## Bromley Lakes Inspection Report

**MINERALS PROGRAM INSPECTION REPORT**  
**PHONE: (303) 866-3567**

<b>MINE NAME:</b> Bromley Lakes	<b>MINE/PROSPECTING ID#:</b> M-1987-049	<b>MINERAL:</b> Sand and gravel	<b>COUNTY:</b> Adams
<b>INSPECTION TYPE:</b> Monitoring	<b>WEATHER:</b> Clear	<b>INSP. DATE:</b> September 24, 2024	<b>INSP. TIME:</b> 13:00
<b>OPERATOR:</b> City of Brighton	<b>OPERATOR REPRESENTATIVE:</b> Scott Olsen	<b>TYPE OF OPERATION:</b> 112c - Construction Regular Operation

# M-1987-049 Permit Area

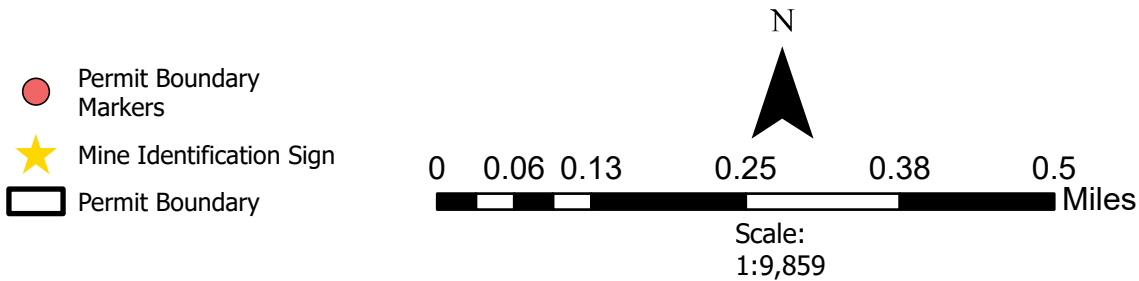
I have outlined the areas in red on the permit boundary map that we will focus on removing from the permit as soon as possible. This will require removal of the stockpiled asphalt millings in the permit area and mechanical treatment of the weeds/invasives in these areas.
